## SUBMITTAL REVIEW COMMENTS

Date: 4/16/18  
Owner: Northwest Seaport Alliance  
Project: West Sitcum Stormwater Treatment  
Contractor: Titon

Submittal Title: Vortex Type Hydrodynamic Separators  
Submittal Number: PO#81368  
TE-001 Shop Drawings REV3

Reviewer: C. Simmons  
Review: TE-001 Shop Drawings REV3: Make Corrections Noted

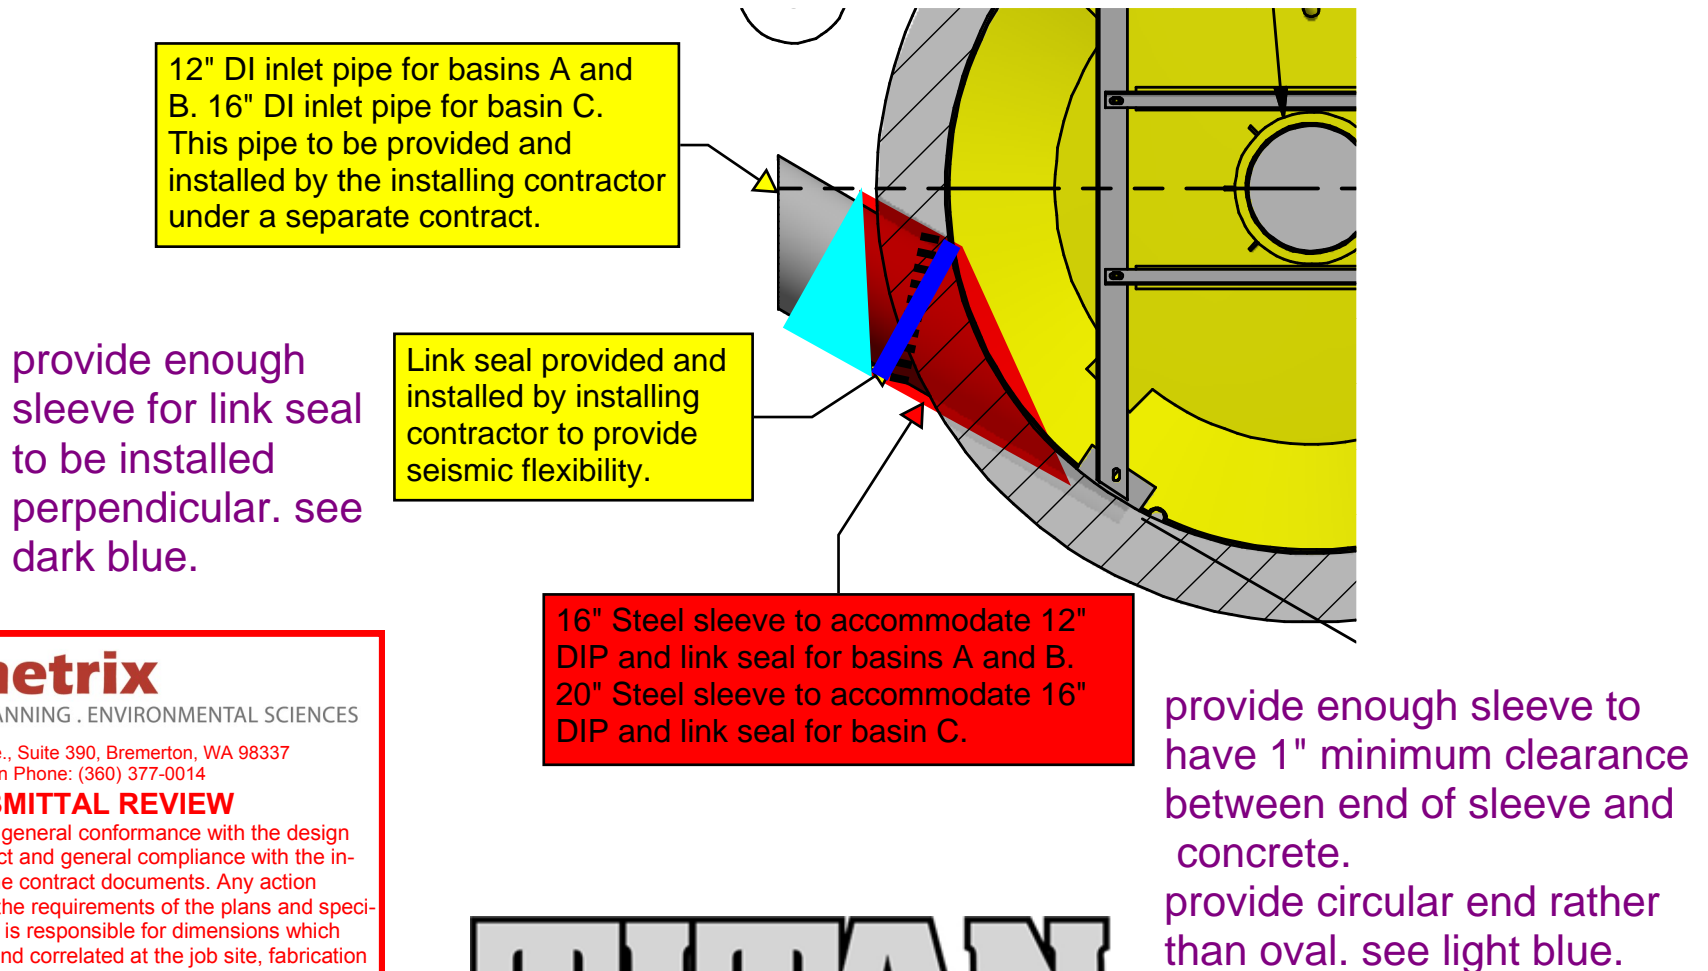
4. Comment resolved
5. Proposed methodology to resolve this issue is approved with minor modifications, as described below and as illustrated in the attached markups on your sixth attachment, "Tangential Inlet Sketch":

- a. Provide enough steel sleeve for link seal to be installed perpendicular. This may have been your intention but it was not drawn that way so I wanted to point it out explicitly.

- b. Provide a circular end to the sleeve that installing contractor can connect to, rather than a sleeve cut with an oval.
  - c. Provide minimum inch clearance between the concrete wall and the end of the sleeve, to help facilitate installation.

Note: TITAN to install steel sleeve tangentially for installation of inlet pipe with link seal within it.
